BULLETIN NO. 1079
ISSUE 2
JUNE, 1947

SIGNAL DISTORTION TEST SET
DXDI, 4 AND 5

CHANGES AND ADDITIONS
TO BULLETIN 1079B, ISSUE 2
SIGNAL DISTORTION TEST SET
DXD5 (BLACK WRINKLE) AND DXD200**

OLD STYLE 82850 END SHIELDS MAY BE WORKED OVER FOR USE WITH NEW STYLE MOTORS BY ADDING WIRE OUTLET HOLE AS ILLUSTRATED.

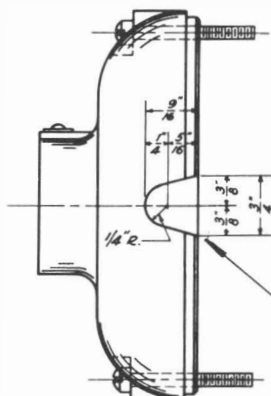
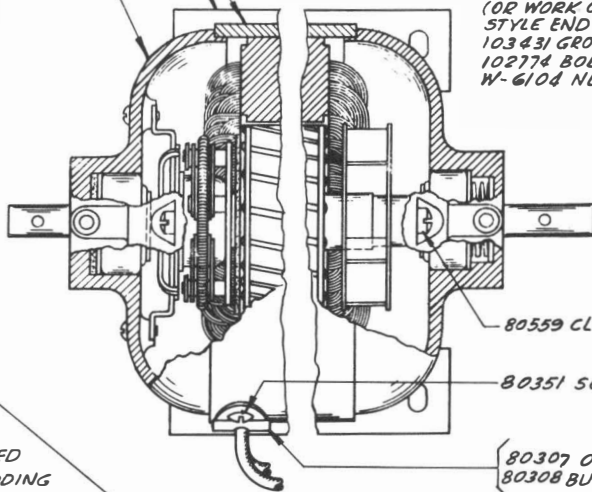
82850 END SHIELD - HAS BEEN REDESIGNED BUT RETAINS ITS ORIGINAL PART NUMBER. THE NEW STYLE END SHIELD (WITH WIRE OUTLET HOLE) CAN ALSO BE USED ON THE OLD STYLE MOTORS. THE OLD STYLE END SHIELD (WITHOUT WIRE OUTLET HOLE) CANNOT BE USED ON NEW STYLE MOTORS UNLESS IT BE WORKED OVER AS ILLUSTRATED BELOW.

90263 WOUND STATOR (WITH BASE) - HAS BEEN REDESIGNED BUT RETAINS ITS ORIGINAL PART NUMBER. WHEN REPLACING AN OLD STYLE STATOR (WITH TAPPED HOLES FOR THE END SHIELD CLAMPING STUDS) WITH A NEW STYLE STATOR (WITH BODY HOLES FOR THE END SHIELD BOLTS) THE FOLLOWING NEW STYLE PARTS SHOULD BE ORDERED:

- 90263 WOUND STATOR (WITH BASE) ----- 1
- 82850 END SHIELD ----- 1
- (OR WORK OVER OLD STYLE END SHIELD)
- 103431 GROMMET - RUBBER ----- 1
- 102774 BOLT ----- 2
- W-6104 NUT ----- 2

115836 SET OF PARTS TO EQUIP A 5 UNIT DXD OR ED38,
WITH INTERCHANGEABLE SEGMENT CODE DISKS

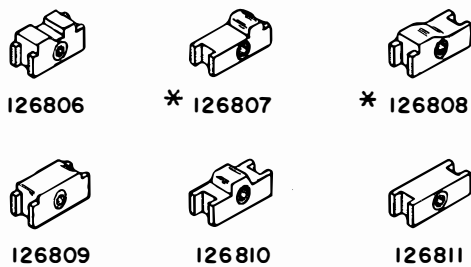
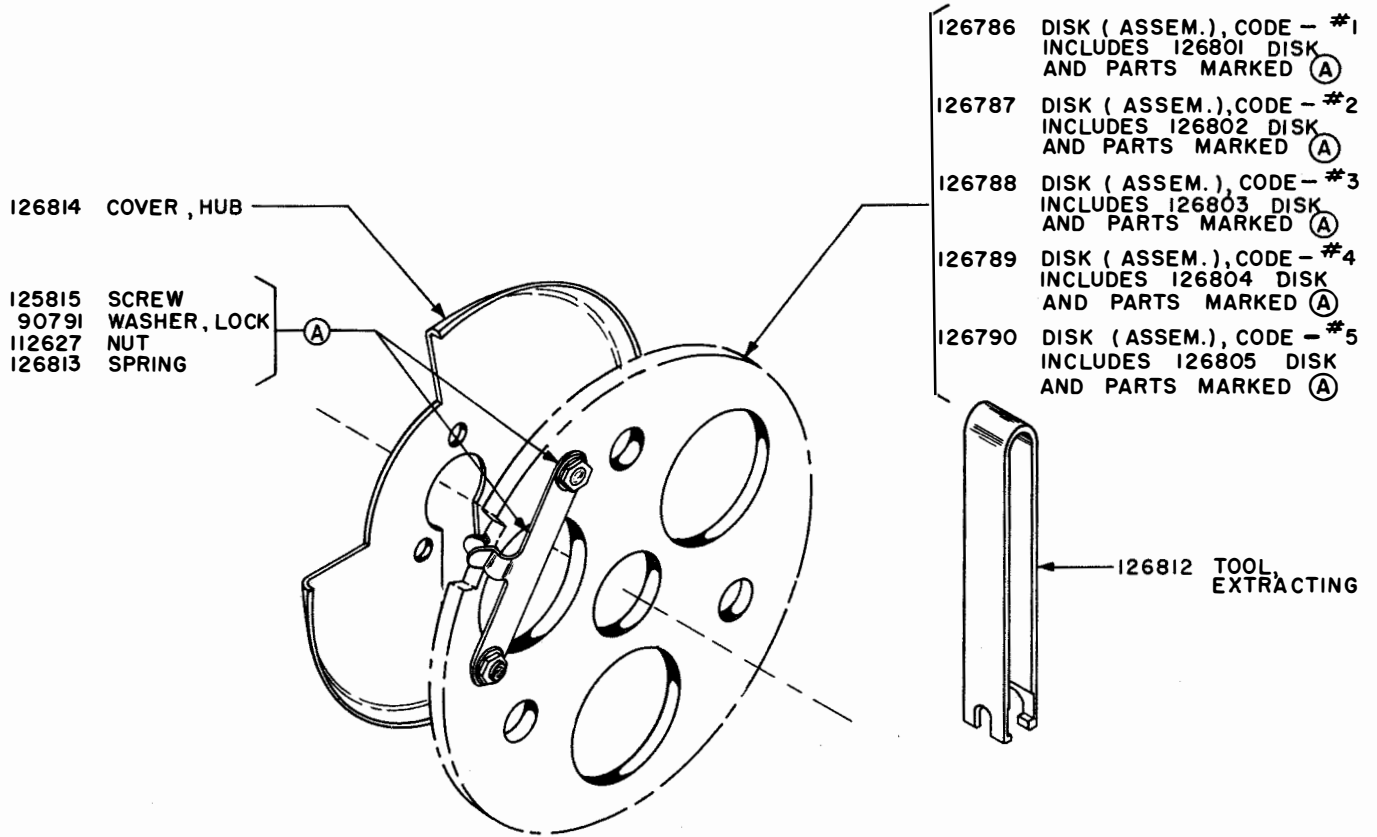
New style test message distributor code disks having interchangeable segments for the station code letters, now replace all old style one piece code disks. When an old style disk is ordered by the part number stamped on the disk a new style disk with the proper segment installed will be furnished. A complete set of code disks with the interchangeable segment feature for conversion in the field can be ordered as a set of parts. New and old style parts are interchangeable.

* When ordering code disk #5 to be used on ED38 it is necessary to use a cover plate with a cut out portion as illustrated on page 2 of this correction sheet.

FIGURE 1

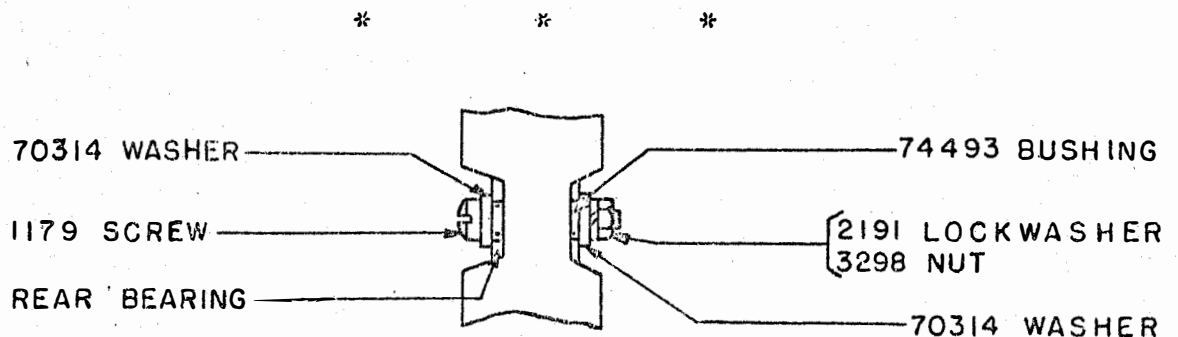
The 83954 bushings (approximately 17/32" long) have been replaced by the 82444 bushings (approximately 15/32" long). In the same contact pile-up, after the 77038 contact spring-long a 41733 plate insulator, 82547 plate insulator and a 84892 contact spring stiffener has been added. A 81726 lug terminal and two 41733 plate insulators have been added after the 81724 contact spring - short. See Figure 1.

FIGURE 2

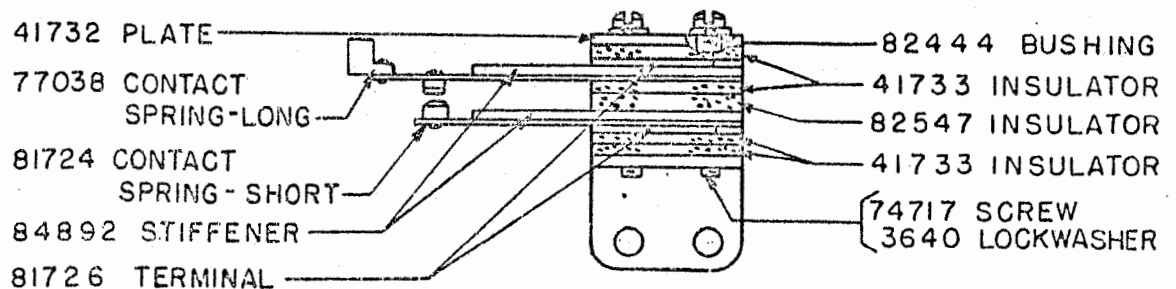
See Figure 2 for additional parts located over the rear 92350 bearing on the 92406 shaft (for adjusting purposes).
